TECHNICAL INFORMATION

Incorrect A/C Refrigerant Label

No: 82/04/04/NAS
Ref:
Issue: 1
Date: 20 December 2004

Discovery Series II (LT)

Figure 1

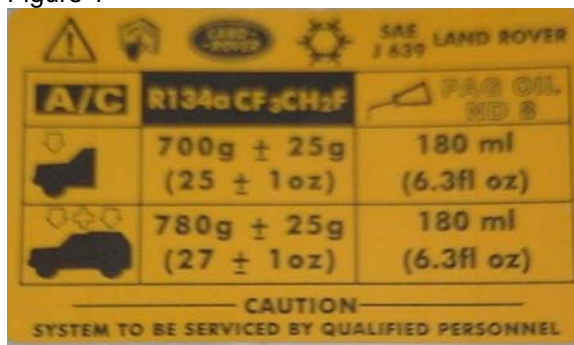
For 2003 and up Model Year vehicles with rear Air Conditioning the English measure in ounces is incorrect on under-hood A/C labels placed on vehicles within the above VIN range. The metric measure is correct at 780 grams.

The figure stated for vehicles with rear A/C in grams on the under hood A/C label is correct. When recharging the A/C system it is best to utilize the gram measurement. If using the ounce value, the correct figure for the system charge is 27oz (± 1). The "32oz" figure on the label is INCORRECT.

If the system is charged to the higher (32 oz) value quoted on the label, premature high pressure cut-out of the A/C will be experienced on a vehicle operating in very high ambient temperatures.

BAC500550A/C Label

(Contains correct metric and English measures)

A/C label with correct information
